LACK OF HEAT—BLOWER MOTOR FROZEN—COLD WEATHER CONDITIONS

TSB 13-11-17

2011-2014 Fiesta

This article supersedes TSB **12-12-7** to remove the production fix date, and update the model years, Service Procedure and Part List.

Figure 1 - Article 13-11-17

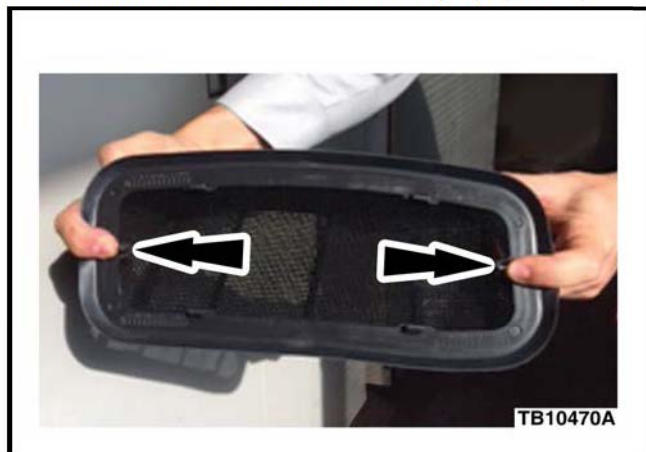
Some 2011-2014 Fiesta vehicles may exhibit a lack of heat resulting from a frozen blower motor. This may be caused by snow entering through the cowl top area. The snow melts and the water enters the blower motor and refreezes during a below freezing overnight soak. The blower motor fuse at location F4 in the power distribution box may also be open.

1. Open hood and remove the cowl panel grill, Refer to Workshop Manual (WSM), Section 501-02.
2. Remove the screen assembly from the bulkhead.
3. Install the new screen assembly. (Figure 1)

- a. Position fingers at the horizontal locator tabs and place screen into position.
 - b. Feel the opening in sheet metal with the back of your fingernails and position screen left and right until you feel it is centered in opening.

- c. Seat the bottom tabs first, pull out fingers and pivot top towards opening to seat the upper tabs.
4. Install the cowl panel grill. Refer to WSM, Section 501-02.
